# **Equivalent system time constant**

**November 2008**

## 25.4.4a.1 Equivalent system time constant¶

# BLW Waveform

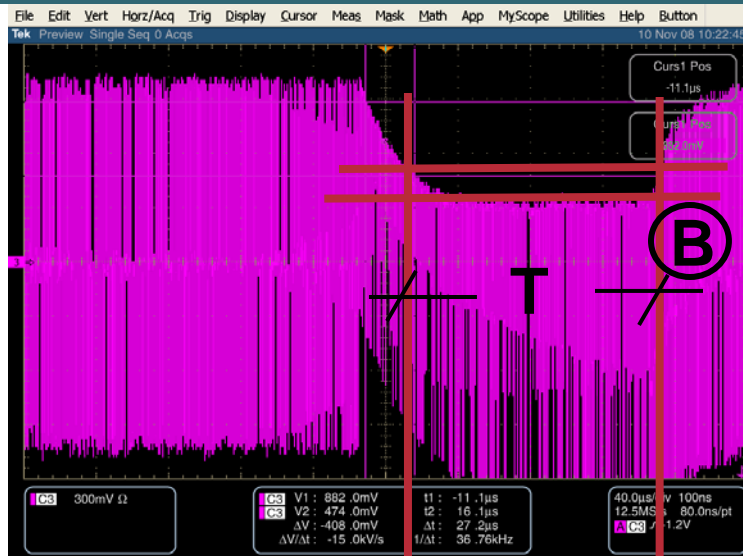
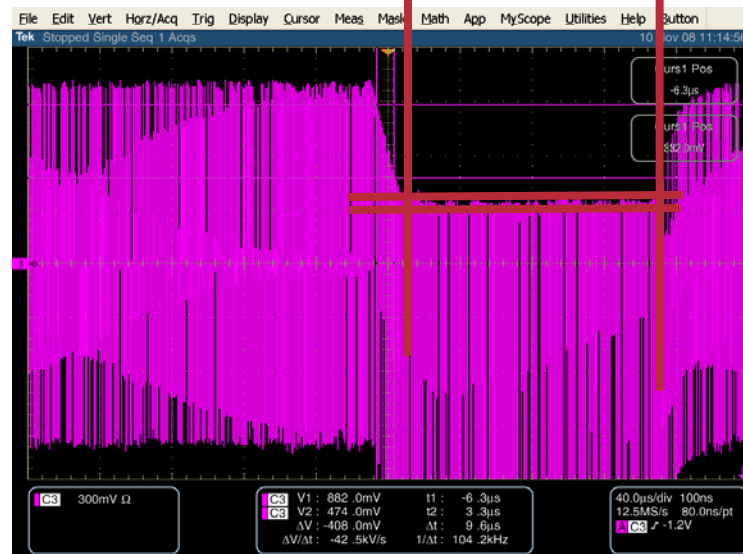
**PROBLEM:** In D3.2, T is fixed from point B.

When the OCL is reduced, the system time constant is more difficult to calculate because the voltage difference between VA and VB is small.

**VA – VC  
OCL1**

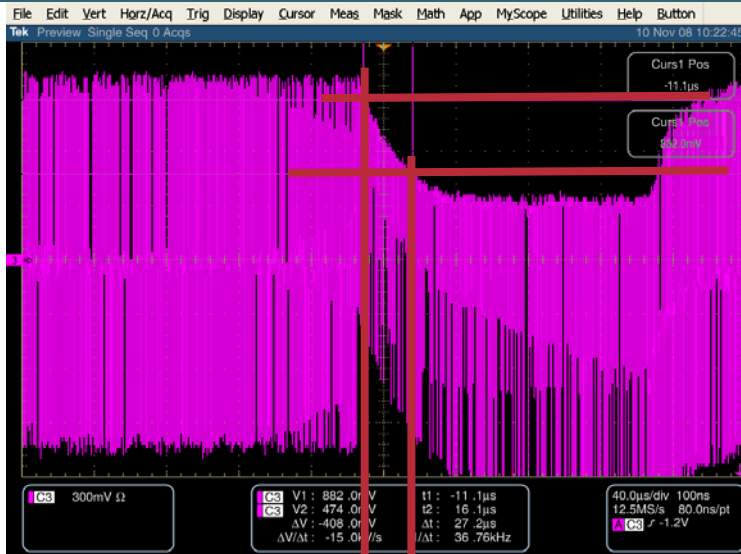
**Solution: Add point C at 20% of decay value and place point A at 80% of the decay value.**

**This ensures a measureable voltage and time difference.**

**Comment 112**

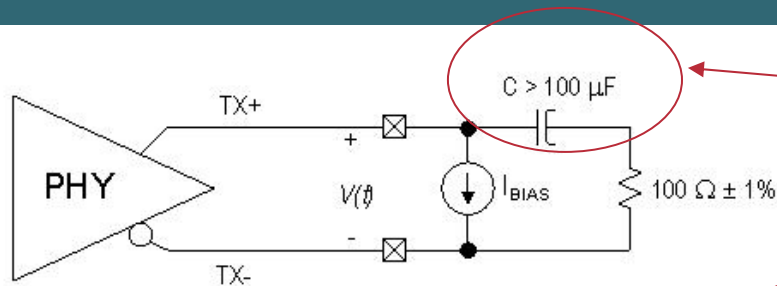
While transmitting the Data Dependent Jitter (DDJ) packet of TP-PMD A.2, using the fixture shown in Figure 25-1, the equivalent system time constant,  $\tau$ , shall be greater than  $2.4\ \mu\text{s}$  when calculated using measurement points A and C as defined in Figure 25-1. Point B is the point of maximum baseline wander droop. ~~Relative to a voltage axis having point B at its origin, Point~~ point A is a point earlier in time from Point B with a ~~magnitude voltage amplitude~~ ( $V_A$ ) that is 80% of the MLT-3 upper envelope value. ~~Relative to a voltage axis having point B at its origin, Point~~ point C is a point between A and B with a ~~magnitude voltage amplitude~~ ( $V_C$ ) that is 20% of the MLT-3 upper envelope value. ... The time between point A and C is T. ... These measurements are to be made for the transmitter pair and observing the differential signal output at the MDI with intervening cable less than 1 m long.¶

~Comment 112

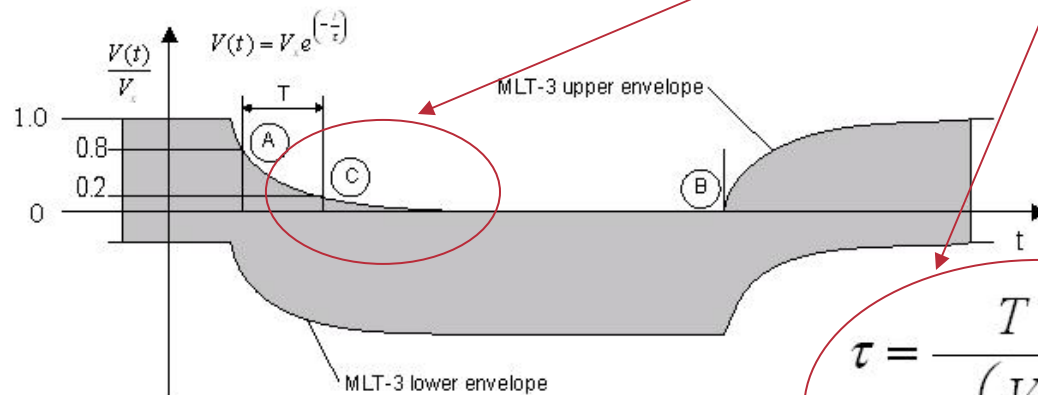
Improves accuracy of this calculation.

New point

Adjust equation to remove negative sign, and provide the time constant relative to operating parameters.

$$\tau = \frac{T}{\ln\left(\frac{V_A}{V_C}\right)} = \frac{2L}{R}$$

Note: The value of  $R$  represents the fixture resistance. The value of  $L$  represents the PHY block inductance.
